Written Final Response

**Albany International
Former Chrome Plant
Groundwater Treatment System
Appleton, Wisconsin**

WDNR ERP# 02-45-000015

Re: Written Final Response
Albany International Former Chrome Plant
Appleton, WI
WDNR ERP# 02-45-000015
CASETRACK# 2009-NEEEE-008

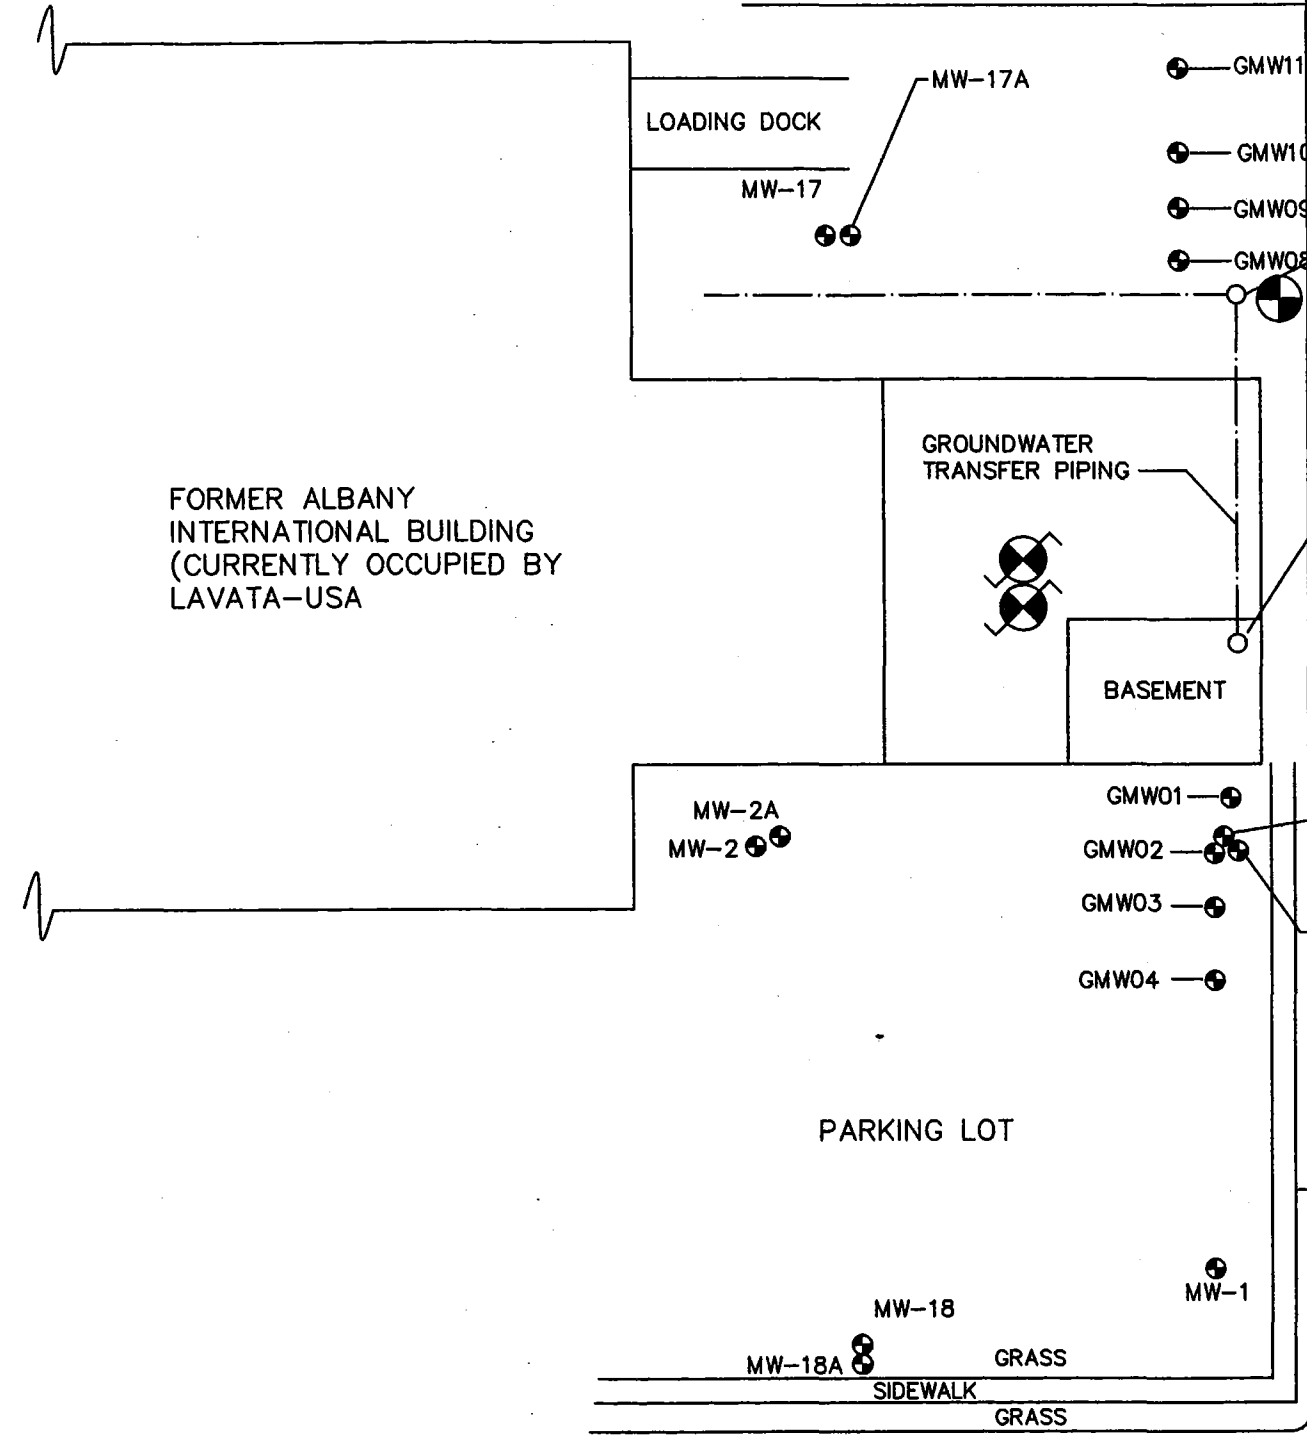
time frame good - confirm location

802 E Winnebago?
 WINNEBAGO STREET

French Drain
 820 N made
 Basement Sump
 MW-10-R
 GMW07
 GMW06
 GMW05
 MW-5*
 MW-5A
 MEADE STREET
 Another well here
 802 N made

Additional site investigation activities proposed for the site at this time include the construction of 2 additional groundwater monitoring wells in the warehouse portion of the building, west/northwest of the basement area. The approximate location of these wells is shown on Figure 1 enclosed. The groundwater monitoring wells are proposed to be constructed as a nest, with one well constructed as a water table monitoring well, and the other constructed as a piezometer. The groundwater table well will be installed to an approximate depth of 22-feet below ground surface (approx. elev.769) to (approx. elev.747). and the piezometer to approximately 40-feet below ground surface (elev. 729) These additional wells will provide for groundwater monitoring in all directions around the source area. We propose to design and install these wells by June 30, 2009.
